YUNEX Technical Bulletin STAB22-0132

Temporary Concession Change on Helios Fixing Kits

Figure 1: Slotted bracket with temp fixing kit

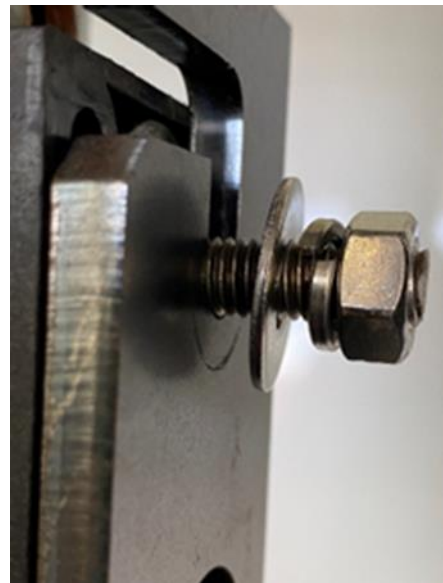
The slotted brackets will continue to be supplied with the signals and the installation instructions, as described in the latest version of the Helios General Handbook 667/HB/30000/000, will still apply. However the fixing kits supplied with the affected assemblies have been modified with the combined nut washer now being replaced with 4x M8 stainless steel nuts, 4x M8 Form C washers and 4x M8 helical spring washers.

The new fixing arrangement is shown in figures 1 & 2. Note that the nuts and washers **must** still be partially assembled before lifting the signal head into position.

HOWEVER it is imperative that the washers do not slide underneath the bracket during lifting of the signal head, they must be on the nut side of the bracket before final installation. If the washers have been pushed behind the bracket during lifting and positioning of the signal head, then they must be repositioned before tightening the nut.
